P.M. Knittex (Pvt) Ltd. (9944)

Chowdhurry Bari, Godhnail, Narayangonj.

01.June.2014

Identified Priority 1 Concerns

1st Priority 1 Concern

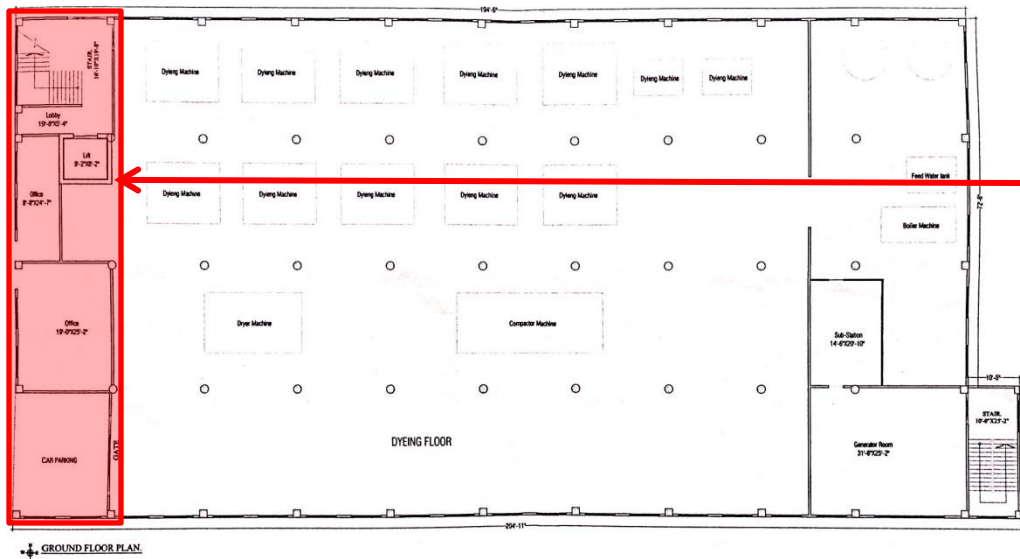
Cooling towers are located on the corner of Building #1.

Our concerns are related to the following points:

- The support structure (a propped slab) is not shown on the provided structural drawings so there was no way to assess the load carrying capacity of the slab.
- The slab is approximately 6m high and supports two large air conditioning outdoor cooler units.

ITEM 2: Priority 1 – Building #1 Cooling Tower support structure appears inadequate.

4th Priority 2 Concern Continue.

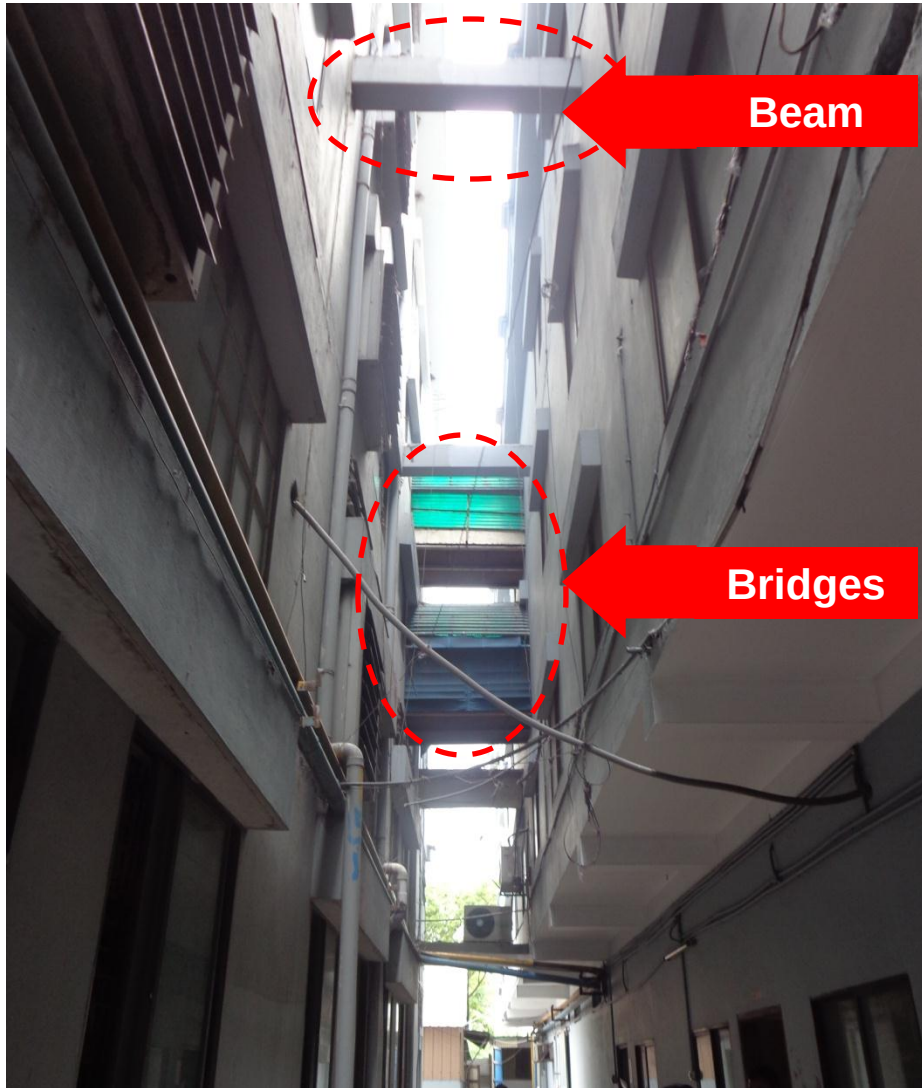
The knitting, generator, waste storage and chemical storage sheds are also poorly built.

Our concerns noted during the survey are as follows:

- Trusses were supported by a brick lintels.
- Steel members not properly restrained or tie down against uplift wind forces.
- Improvised truss support details.
- Weak bamboo and timber supporting members.

ITEM 6: Priority 2 – Knitting, Generator, Chemical storage and waste storage sheds are poorly constructed.

1st and 2nd floor levels

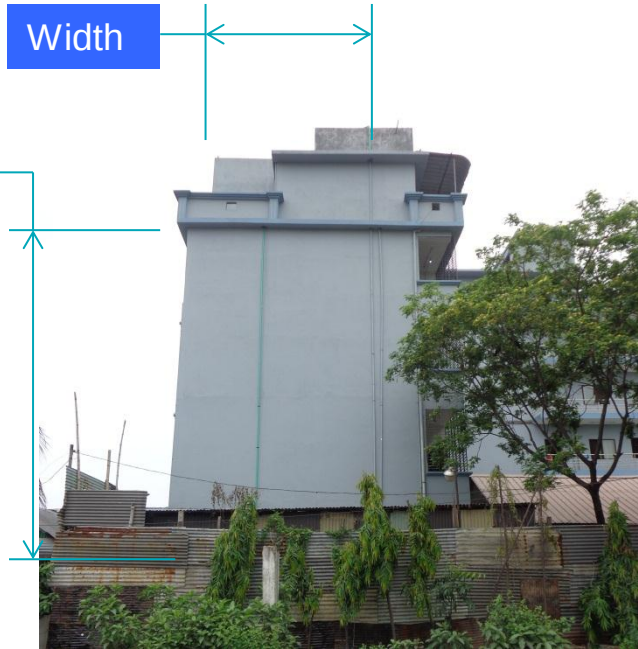
We believe that the intent of the original structural design was to use the main grid line beams to provide some form of lateral stability via moment frame action although no ductile detailing is provided on structural drawings.

However, in Building #1, there are beams in one direction at 1st and 2nd floor levels; in the short directions only.

We require that these items be investigated in a Detailed Engineering Assessment.
